STAFF REPORT

Community Planning and Preservation Commission Certificate of Appropriateness Request

| Case No.: | 21-90200096 |
| Request: | Review of a Certificate of Appropriateness for conversion of a detached garage at 3040 8 th Ave. N., a contributing property to a local historic district. |

Figure 4: Existing and proposed alley-facing (south) and interior-facing (north) elevations from application

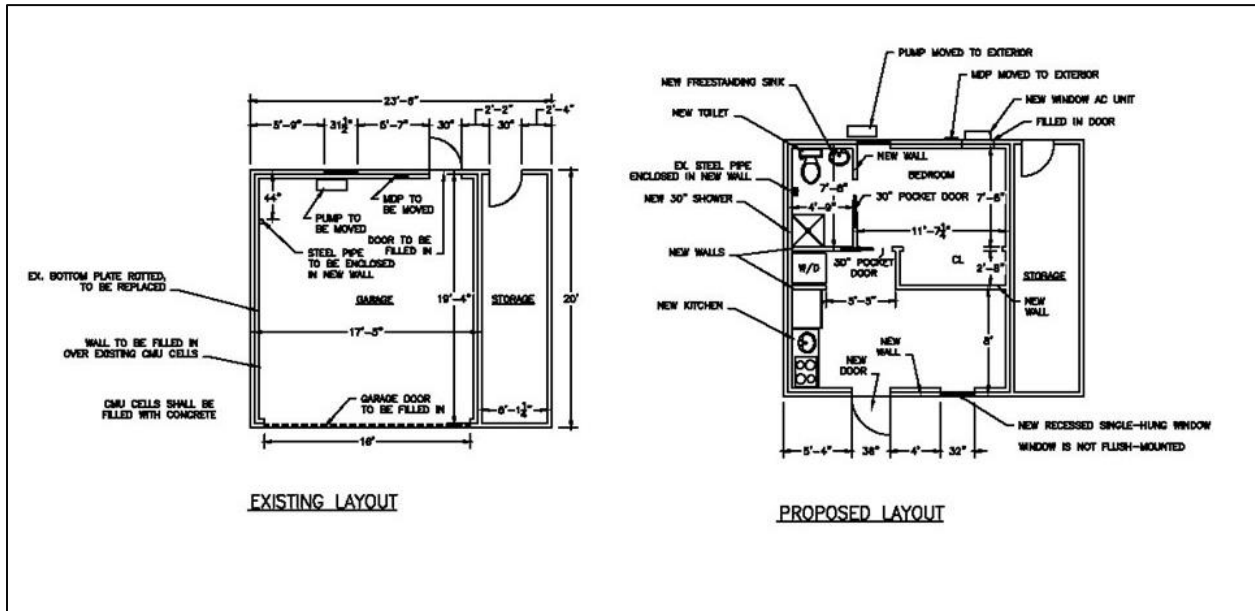
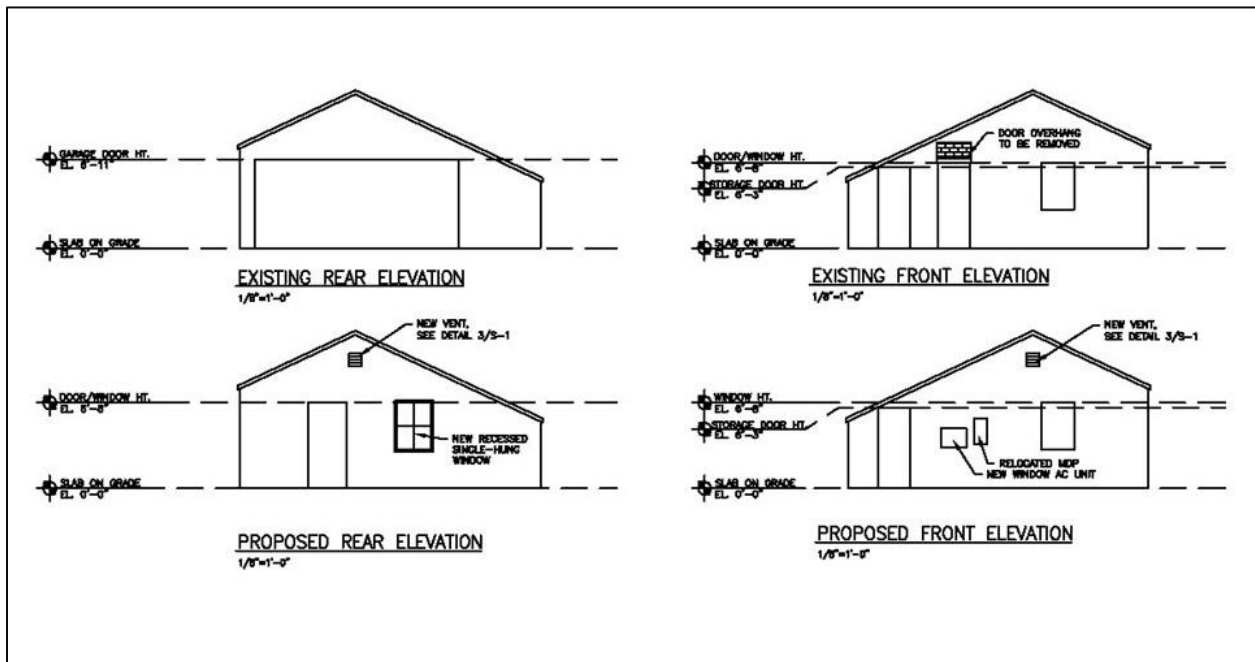
The proposed changes to the detached garage building will alter its fenestration but not its overall form. Because this building is primarily visible from within the subject property and the rear alley, there will be minimal impact to the overall integrity of the containing local historic district.

The proposed changes to the garage building will impact the visual use by removing the (non-historic) garage door and introducing a single-action door and window at the alley elevation. However, detached accessory buildings constructed in the subject district have historically included apartments and garage apartments, as well as freestanding garage buildings. These buildings were typically fairly utilitarian in design and many have evolved over time to meet the needs of property owners. The proposed windows and doors to be introduced reference the general style of the primary residence and will not be highly visible.

Generally consistent The enclosure of the garage door opening will slightly alter the garage building's depiction of the subject property's historic use. However, the change will not be visible from the primary street and is overall sensitive to the residence's appearance.

1. Windows will be installed to be setback within the wall plane and feature a reveal of at approximately two to three inches to provide consistency with the historic windows at subject property.
2. Proposed windows and doors will replicate traditional design and configuration. Windows installed at converted garage should feature contoured, three-dimensional muntins in a six-over-six configuration to continue pattern of existing windows.
3. Parking design and arrangement of rear fence will be coordinated with Historic Preservation and Zoning staff to comply with all relevant aspects of City Code.
4. All other necessary permits shall be obtained. Any additional work shall be presented to staff for determination of the necessity of additional COA approval.
5. This approval will be valid for 24 months for an expiration date of October 12, 2023.

| SCALE AS SHOWN | DRAWING No. T-1 |

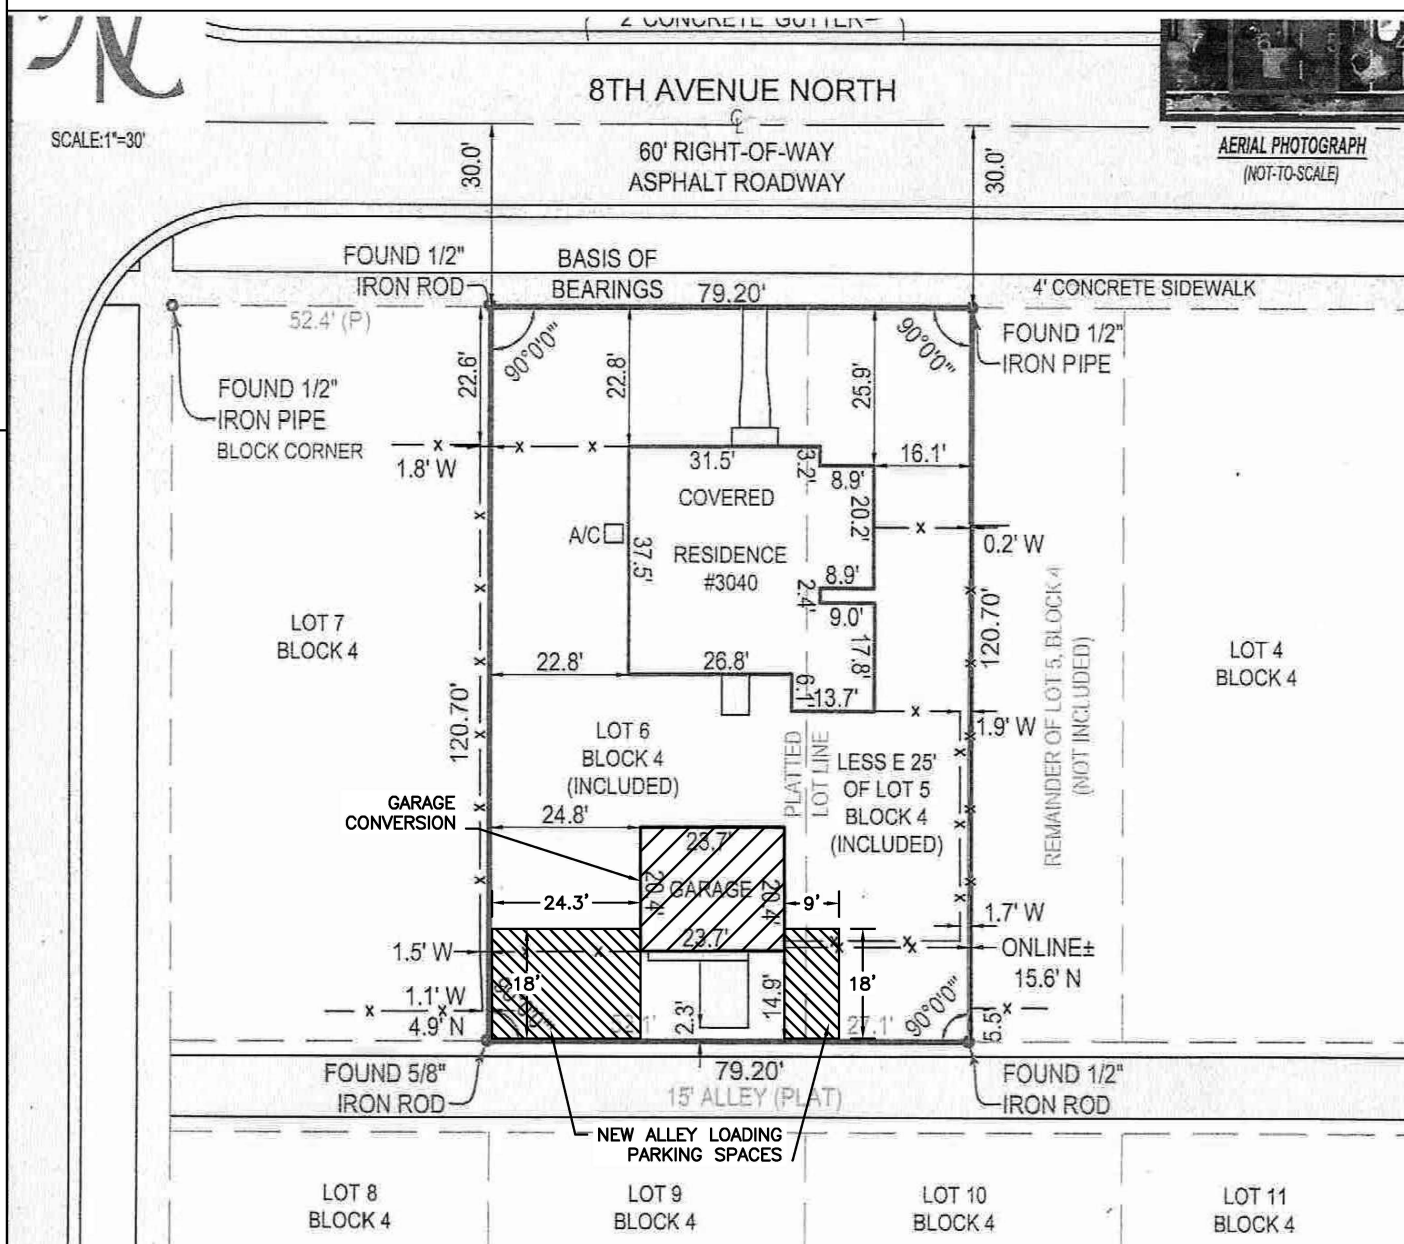
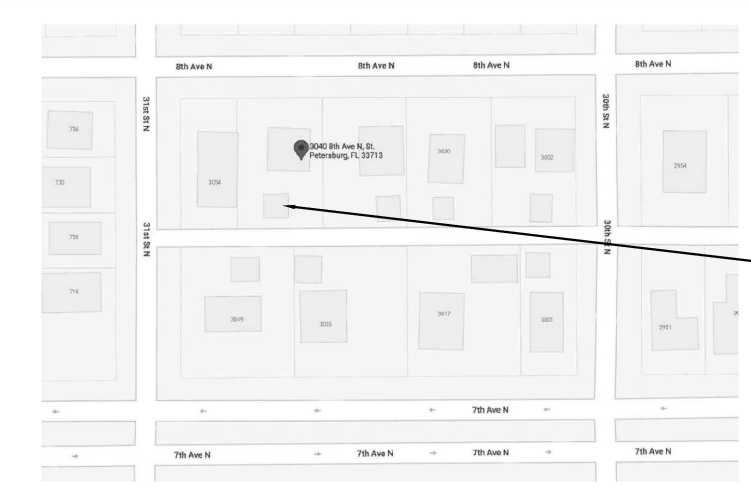
1. Comment: Three (9'x18') alley loading parking spaces required on-site. One unencumbered parking space required per Section 16.50.010. Crushed shell not permitted as a parking surface.

Response: Handled. Required parking spaces added to site plan. See T-1.

| SCALE | DRAWING No. |
|---------------------------|---|
| AS_SHOWN | A-1 |

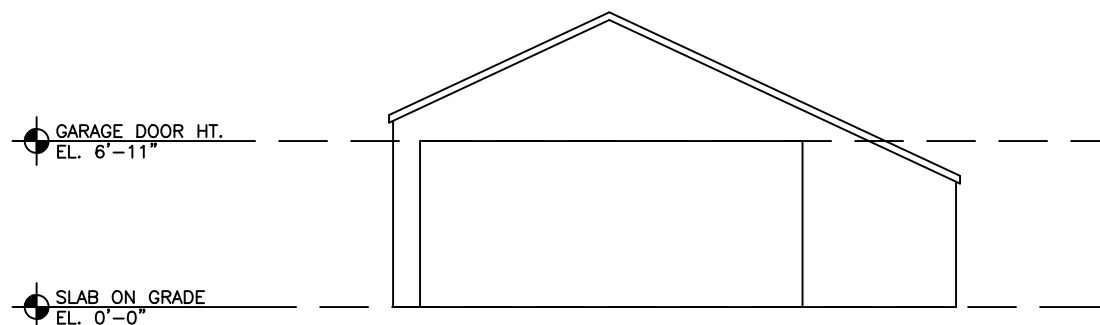
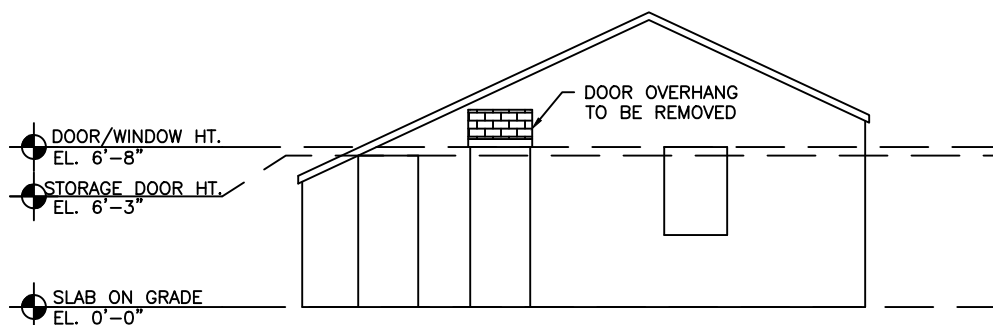
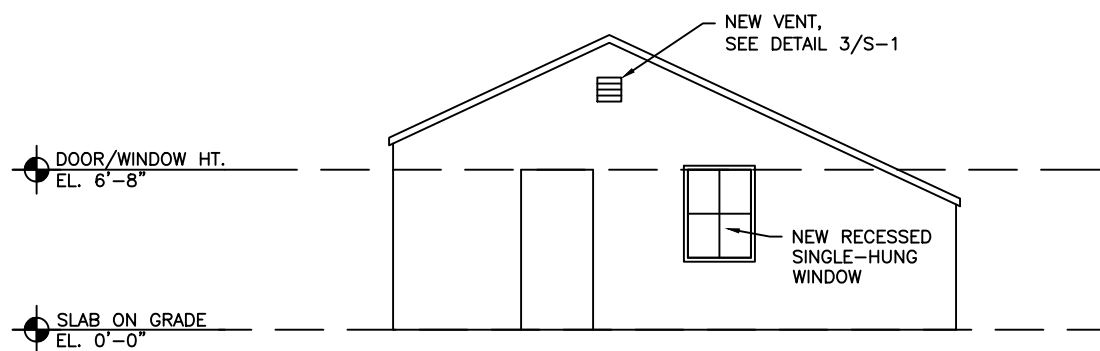
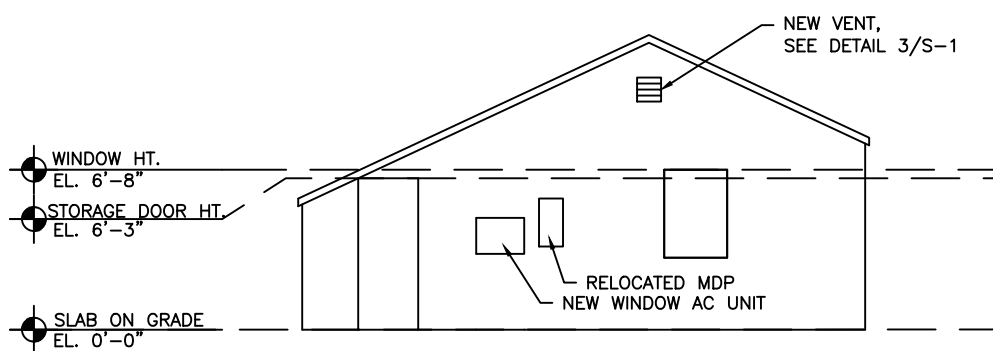
2. Comment: Per Section 16.20.010.11., "Windows shall not be flush mounted. Windows recessed less than three inches shall feature architectural trim including a header, sill, and side trim or decorative shutters. Windows recessed three inches or more shall feature a windowsill."

Response: Handled. Window is not flush mounted. It is a recessed single-hung window with header, sill, and side trim. Walls are doubly thick to account for above ground concrete footer existing in structure. See A-1 and Product Approval List on N-1.
